REQUEST FOR TENDER No. 22-044

Quennell Lake Floating Dock and Gangway/Ramp Design Build Project

Addendum 1

Issued: April 27, 2022

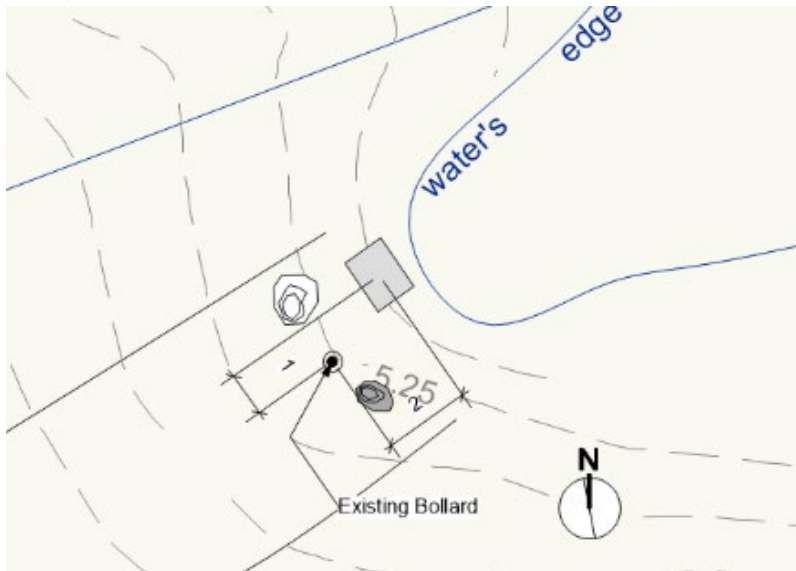
Q2. Can the RDN provide the placement location of the concrete block?

Distance away from the steel pole;

At the center of the opening;

To the left;

To the right; there is a note that states the ramp is "not to inhibit the current access".

Having the block placement coordinates allows WCFS to ensure this clause is met and there is no interpretation by WCFS;

A2. Concrete block to be located North (left) side of existing bollard. Center of Block to be approximately 1m north and 2m east offset from existing bollard. RDN representative to approve of location prior to excavation. Boulder on North side of bollard will need to be shifted.
